FINAL ENVIRONMENTAL IMPACT STATEMENT

Deerpark Village Town of Deerpark, Orange County, NY

Applicant: Deerpark Village Associates

February 2012

Figure I-1

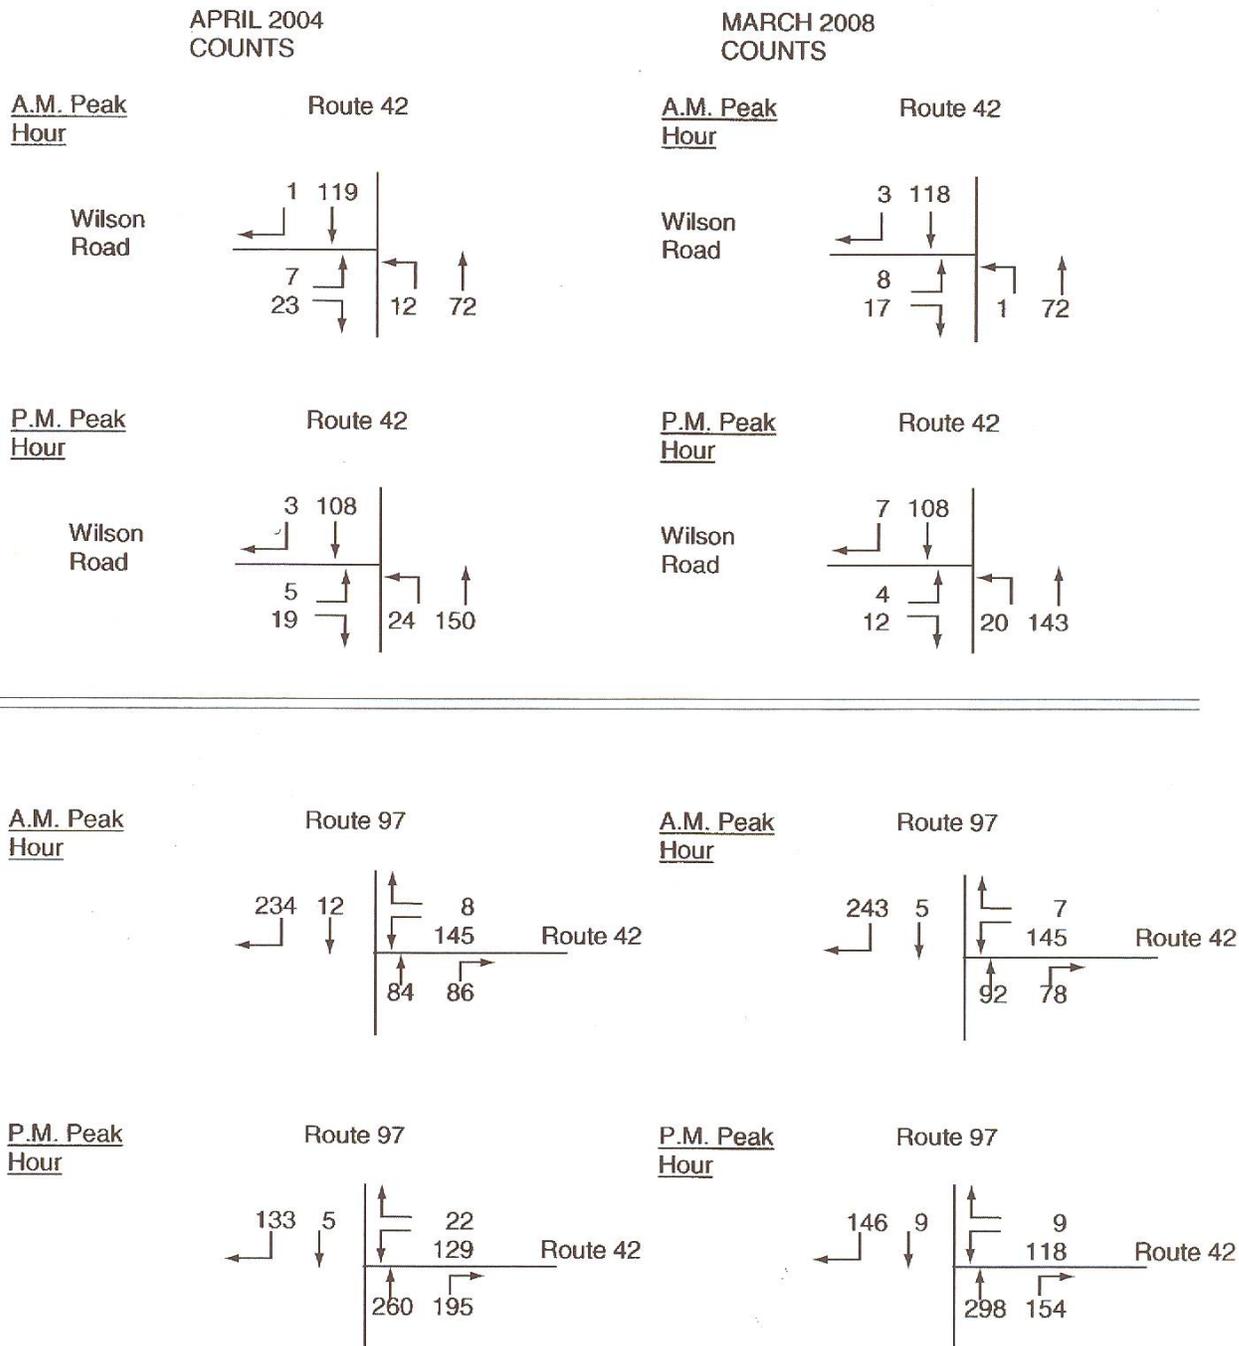
The comment is made in Comment Letter F submitted by the Wilson Road Coalition (see Appendix 12, page 46) that “The methodology, particularly with respect to existing conditions on Routes 42 and 97 also did not account for the seasonality of traffic associated with the Scenic River Corridor and the resulting increased traffic associated with summer tourism in the region.”

A comparison of the two set of traffic counts shows very little change from 2004 to 2008. Traffic volumes on Route 97 increased slightly, while traffic volumes on Route 42 and on Wilson Road decreased slightly. Traffic volumes on the combined section of Routes 42 and 97 remained essentially unchanged. Both sets are one-day counts, and the differences could fall within normal day-to-day variations.

Figure I-2

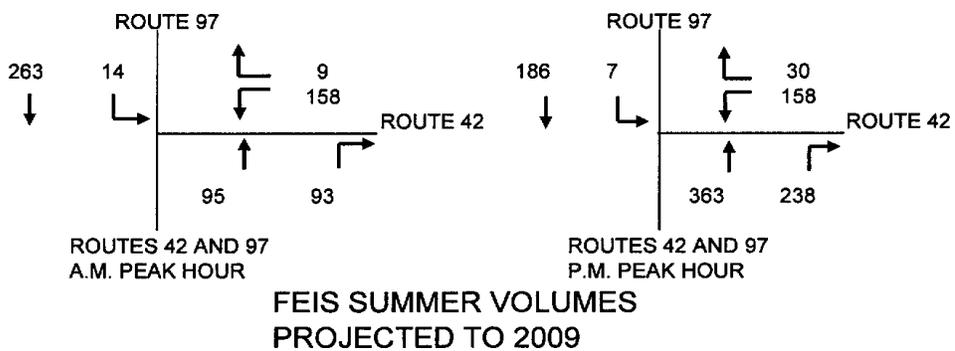
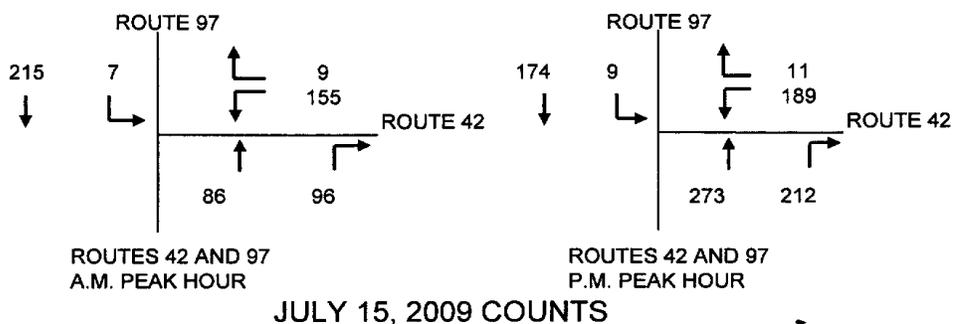
At several meetings subsequent to the Town’s receipt of the draft FEIS dated February 2009, some members of the Planning Board, as well as the Board’s review consultant, Alfred A. Fusco, Jr., PE, raised a question about the validity of the analytical method used in the draft FEIS to arrive at assumed summer season traffic volumes. As previously noted, the analysis was undertaken in response to a comment during the

In order to respond to the Board’s question and concern about the validity of the methodology during its review of the first FEIS draft, Parish & Weiner commissioned a summer 2009 survey for the heaviest volume intersection, Routes 42/97.

The new traffic count at the intersection of Route 42 and 97 was made on Wednesday, July 15, 2009 from 7:00 to 9:00 AM and from 3:30 to 6:30 PM. The peak hours were determined to be 8:00 – 9:00 AM and 4:15 – 5:15 PM. The resultant peak hour volumes are shown in the top two diagrams of Figure I-2 on the immediately following page.

The two diagrams at the bottom of Figure I-2 show the peak hour volumes that were utilized in the summer season analyses in the draft FEIS.

Thus, the actual traffic counts are lower than those which were calculated in the draft FEIS and used in the analysis. This sensitivity analysis establishes that the assumptions were used in the FEIS analysis were valid and, in fact, projected larger impacts, than can be expected. It is also noted that the 900 unit development alternative would reduce traffic generation by about 40%.

This drawing, identified as Figure II-3 and dated June 2008, is found following this page and is presented as a reduced size color print. A full size black and white folded print at a scale of approximately 1” = 200’ is included in FEIS Appendix 17.

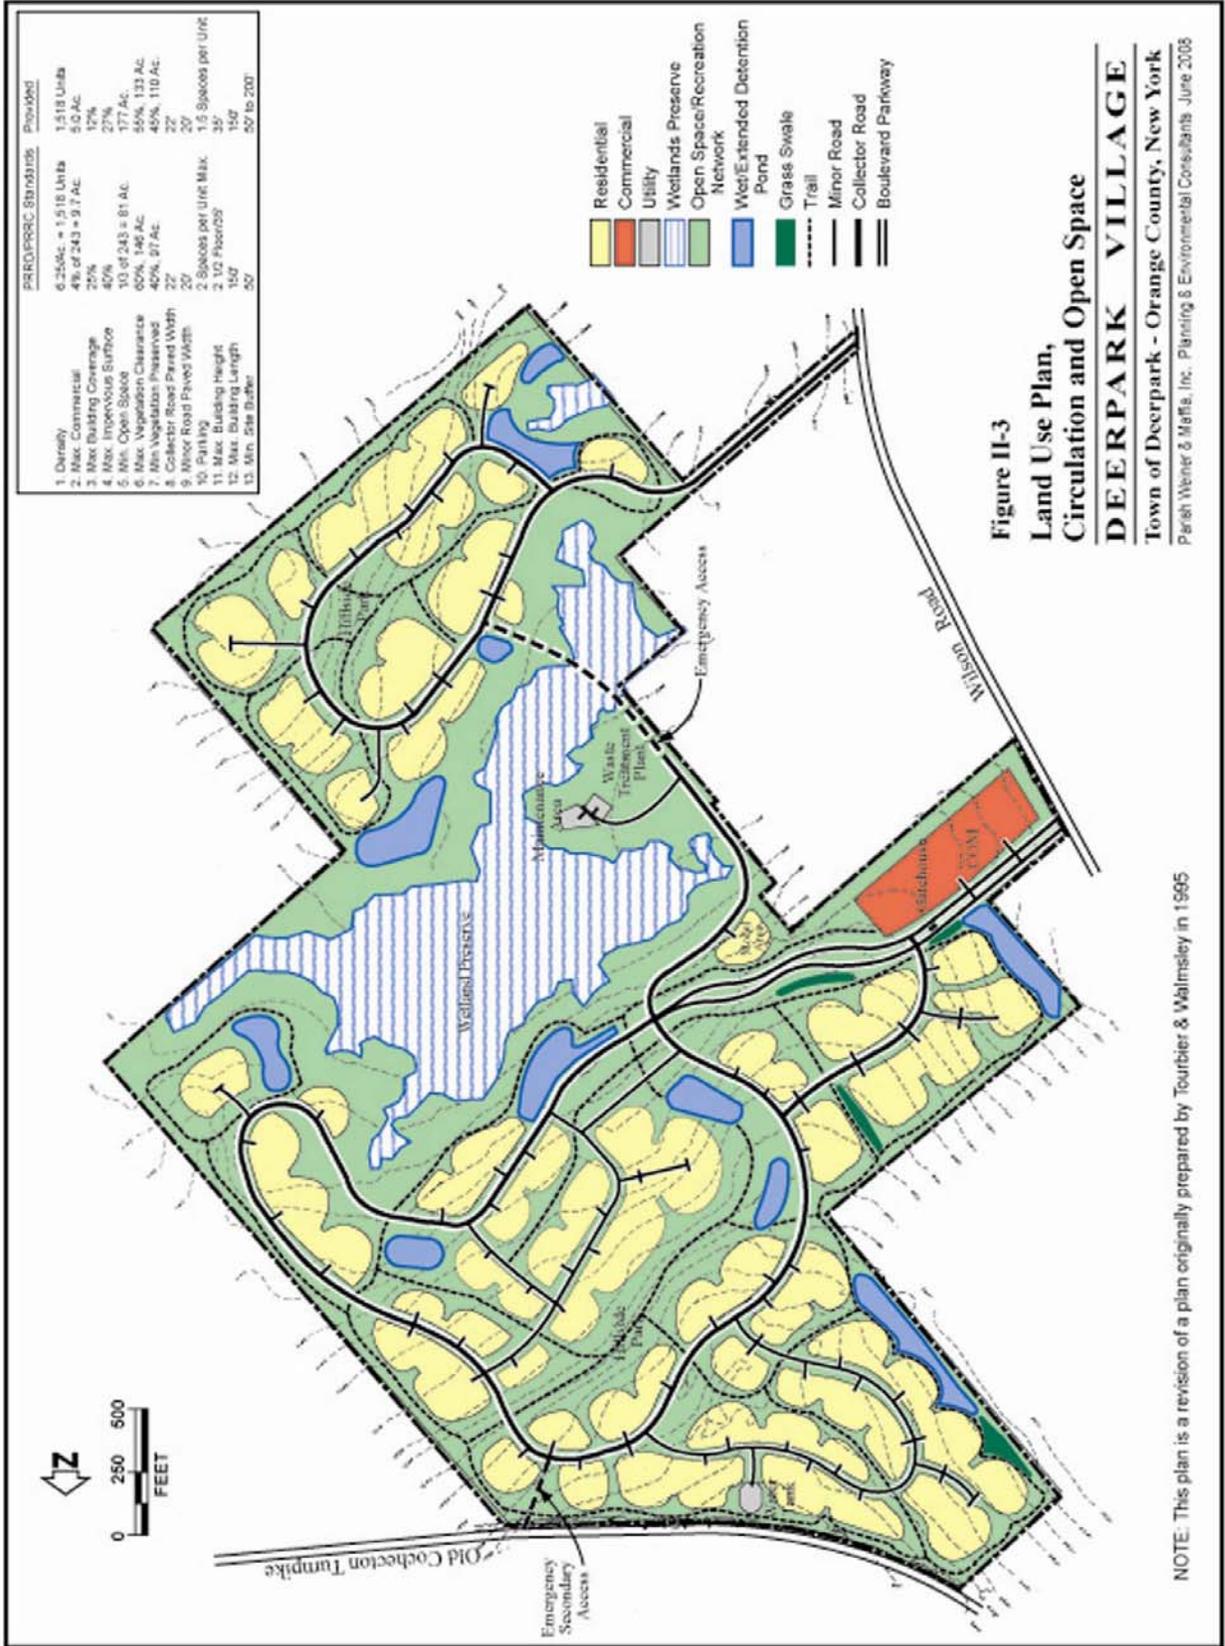
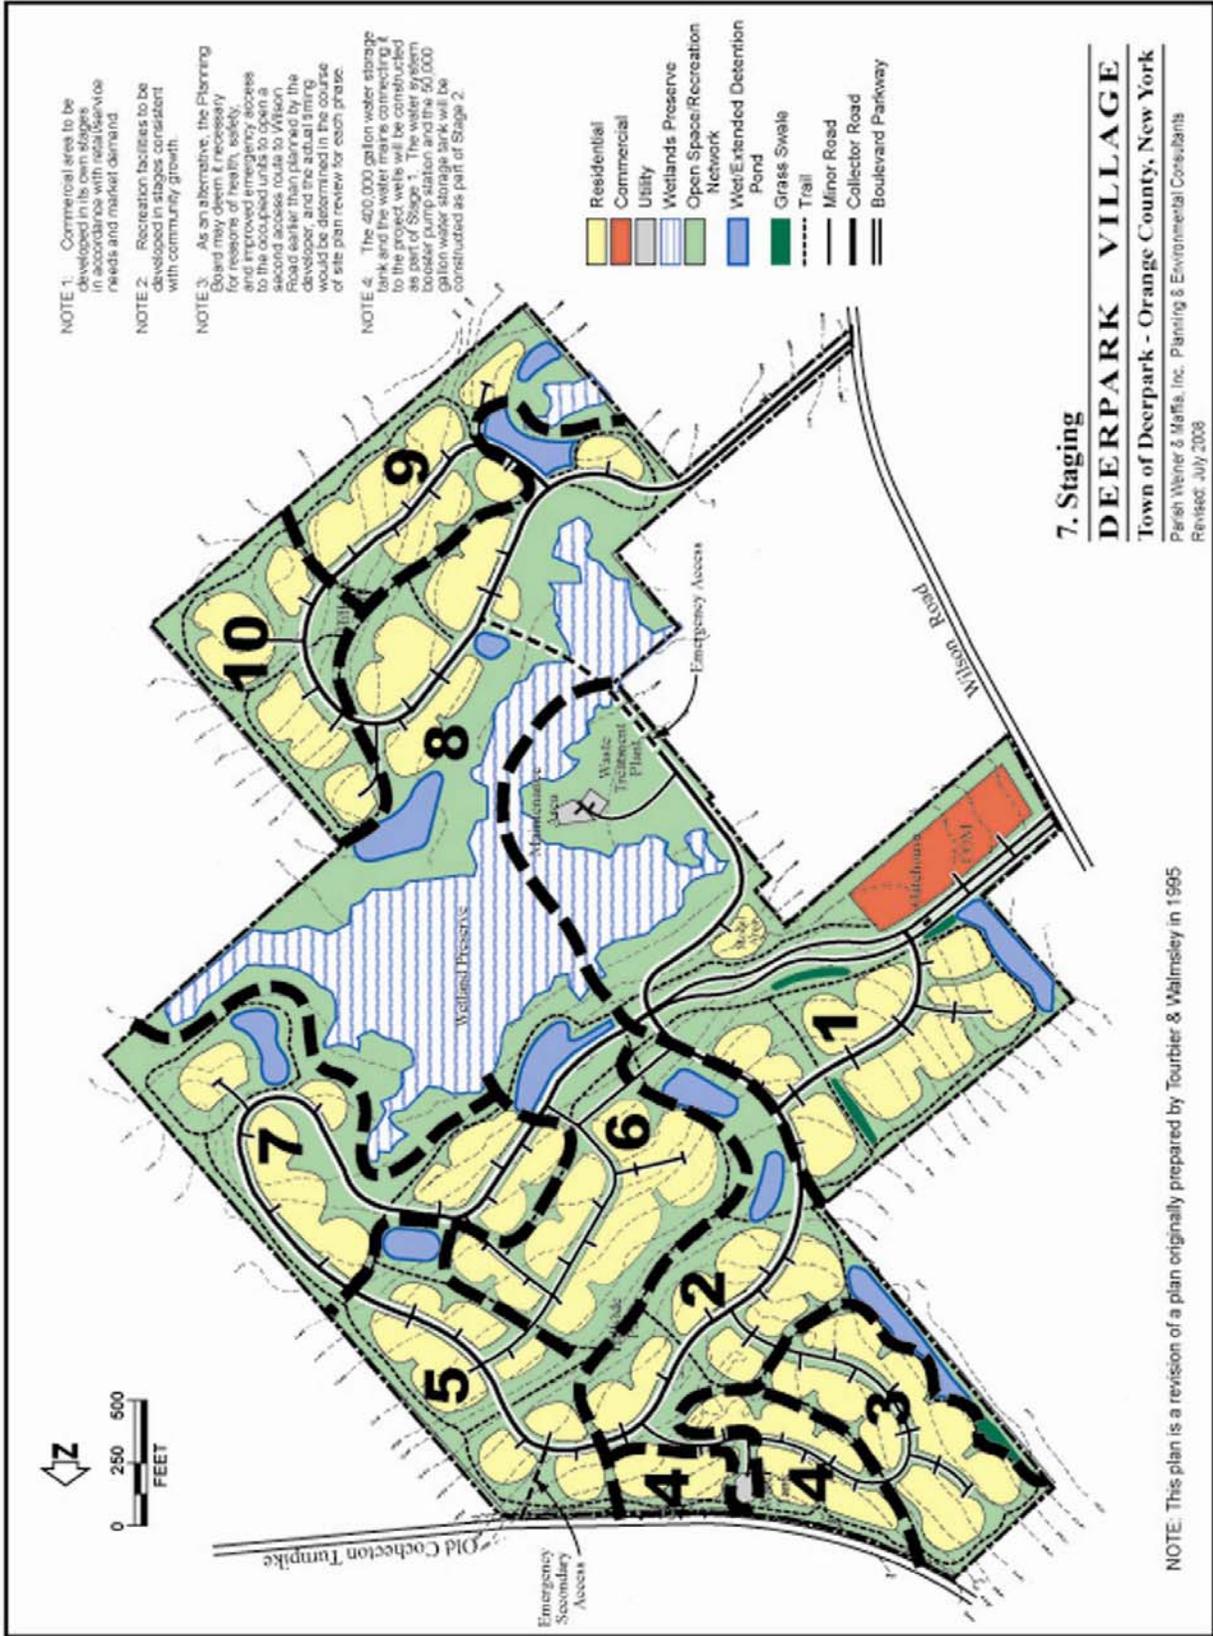
Some comments noted that stormwater retention areas shown on SDEIS Figure IV-27 (Conceptual Drainage Plan) are not shown on SDEIS Figure II-3 (Land Use Plan, Circulation and Open Space following SDEIS page II-1). Other comments indicated that: (a) the proposed sewage treatment plant (STP) is very close to neighboring residential property; (b) the project located a road through the yard of an adjacent residential property.

Figure II-3 has been revised to show the location of each stormwater retention area shown on SDEIS Figure IV-27 (following SDEIS page IV-69). The revised Figure II-3 is dated June 2008 and is shown in FEIS Section I in the sub-section titled “Revised Plan Drawings”.

The location of the STP, as shown on the revised Figure II-3 dated June 2008, is approximately 300 feet from the nearest property line and more than 1,000 feet from the nearest building on neighboring residential property. This is deemed to meet recognized standards which normally require a distance of 500 feet to the nearest residential structure.
